TO: Planning Commission

FROM: Lisa Anderson-Ogilvie,  Urban Planning Administrator

APPLICATION: Fairview Refinement Plan, Partition, & Phased Subdivision  
Case No. FRP-PAR-SUB14-01

RECOMMENDATION: APPROVE Fairview Refinement Plan, Partition, and Phased Subdivision Case No. FRP-PAR-SUB14-01 subject to the following conditions:

Figure 4: Typical Street Sections

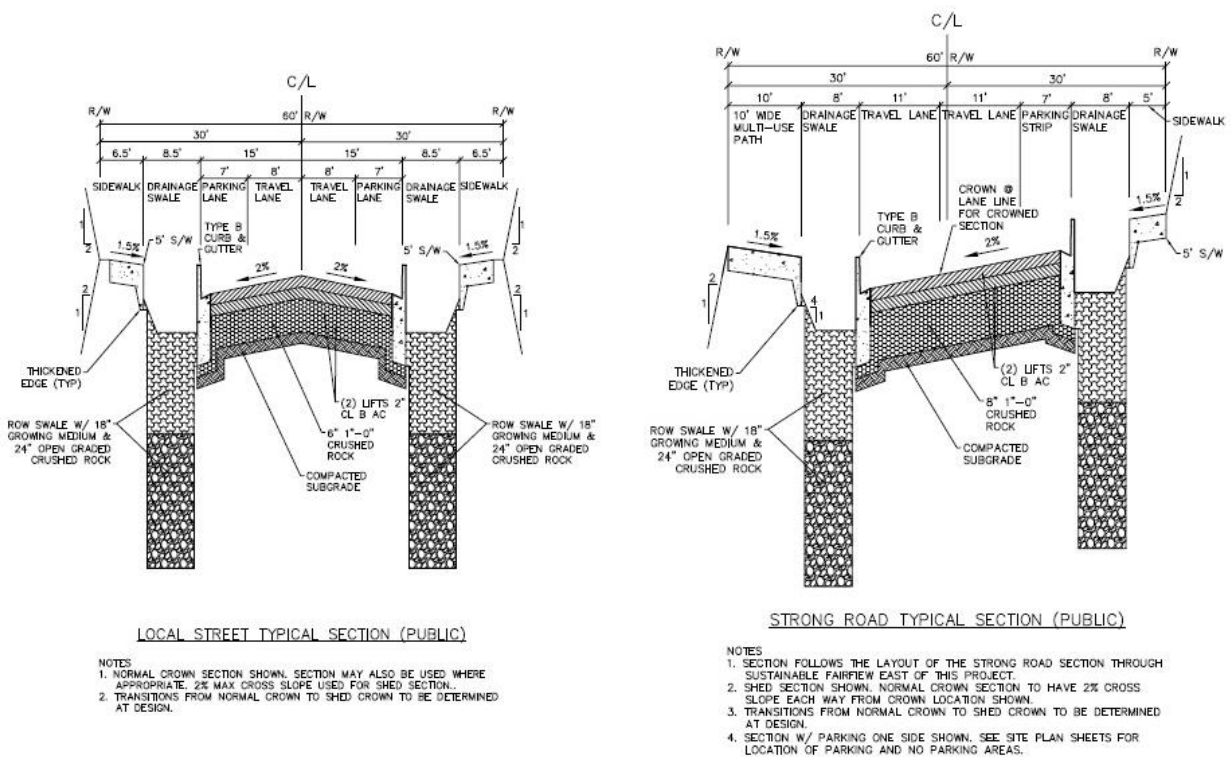
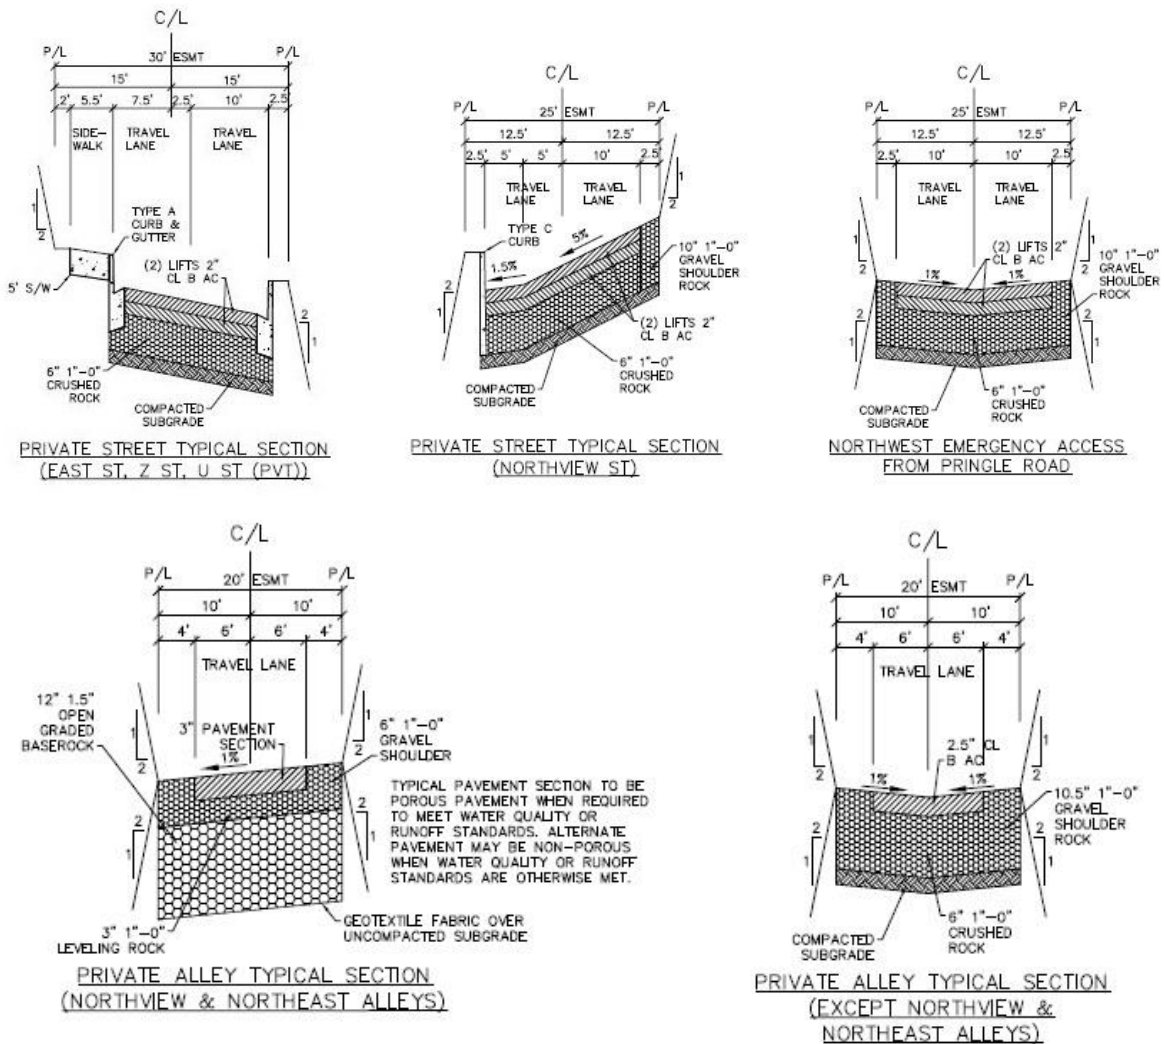
**Condition 1:** The third paragraph of the refinement plan, under Section 4 (Typical Street Cross Section) on page 16, shall be amended to read as follows:

**Condition 2:** The refinement plan shall be amended to remove pavement, crushed rock, and other sub-grade dimensions from the street cross sections included under Section 4 (Typical Street Cross Sections).

**“Please refer to the following diagrams in Figure 4 for typical road cross sections. Note that subbase and drainage rock will vary according to specific site conditions. Final structural street sections are addressed by the Public Works Design Standards and will be determined at the time of final design.”**
